Subject: McGuire Nuclear Station
Docket Numbers 50-369 and -370
Catawba Nuclear Station
Docket Numbers 50-413 and -414
Oconee Nuclear Station
Docket Numbers 50-269, -270, and -287
Request for Additional Information Relative to DPC-NE-3000P, Revision 1;
Responses to Questions

Attachment 3

Figure 4-1

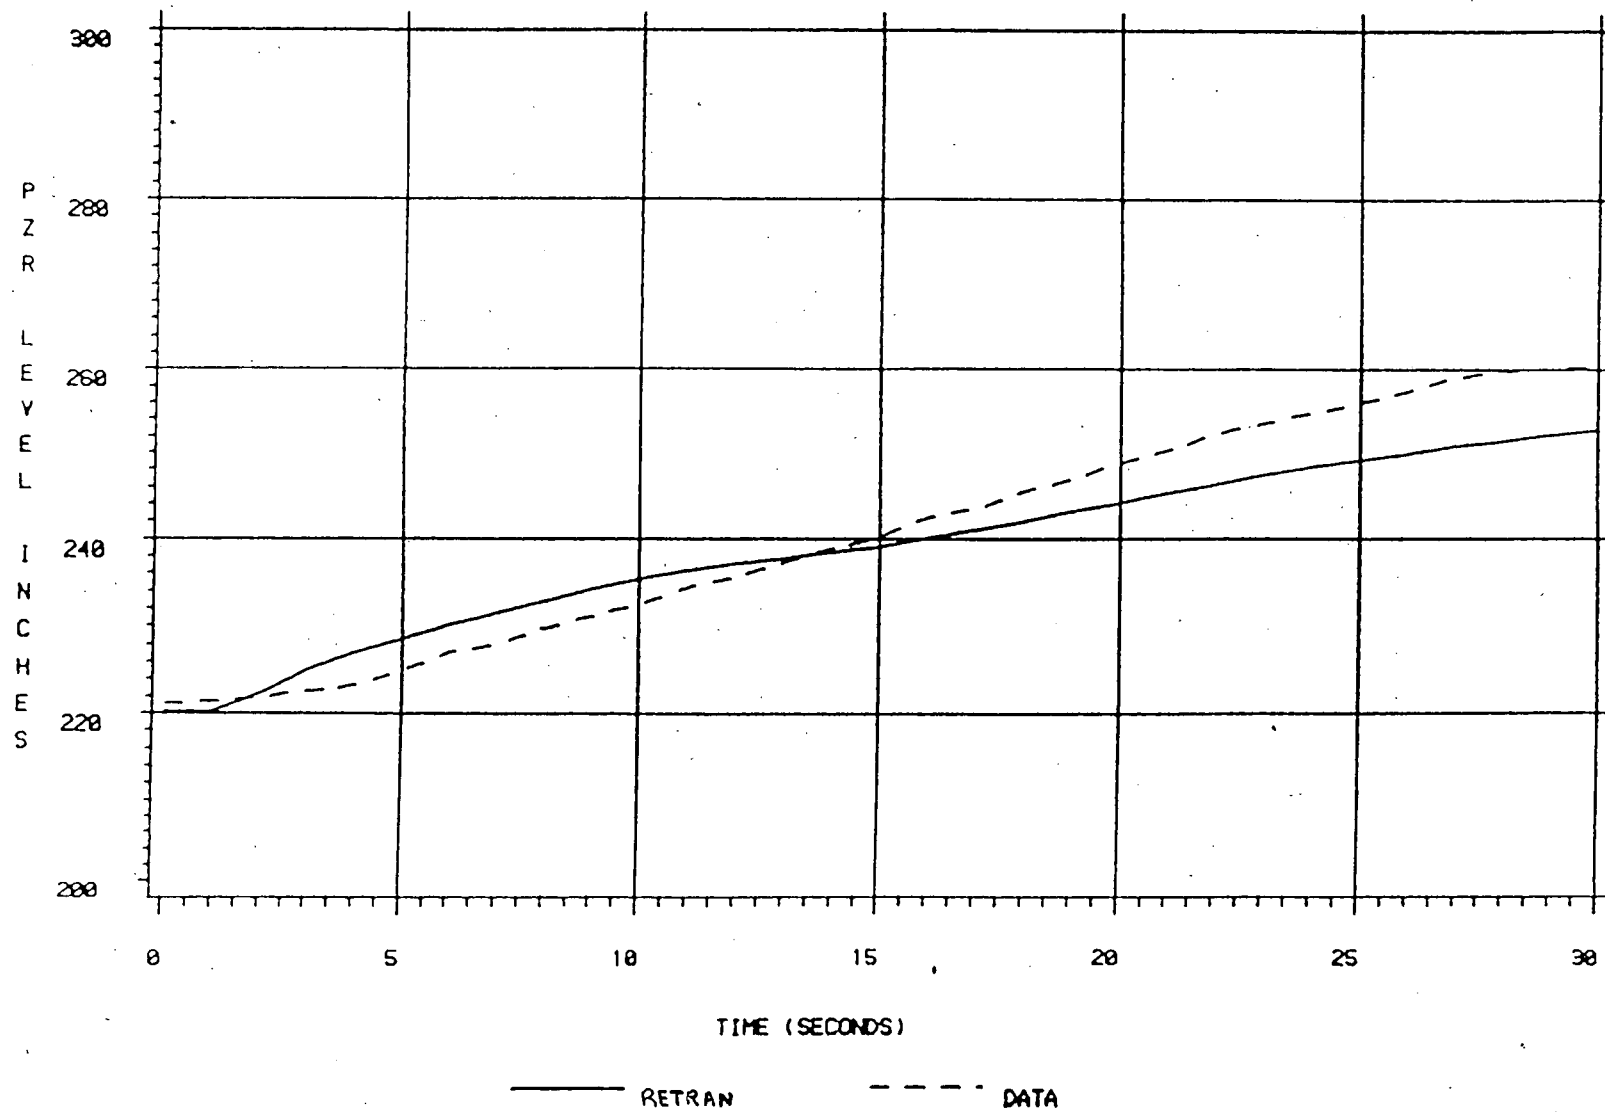
Demonstrate by reanalysis of transients/tests that the revised PZR model with heat conductors results in adequately conservative predictions. In addition, DPC should qualify its PZR water level prediction procedure. (p. 2-42 & p. 3-47)

This revised model was benchmarked against plant data from a turbine trip from 37% power. This event is characterized by a reactor power decrease from 37% to 28% over 27 seconds. The pressurizer level response is shown in the attached Figure 4-1. RETRAN slightly overpredicts the pressurizer level during the first 15 seconds. After 15 seconds, RETRAN slightly underpredicts the pressurizer level. These deviations are the result of the integrated effects of the core power and primary-to-secondary heat transfer predictions versus plant data. The overall comparison of the pressurizer level prediction to data is reasonable.
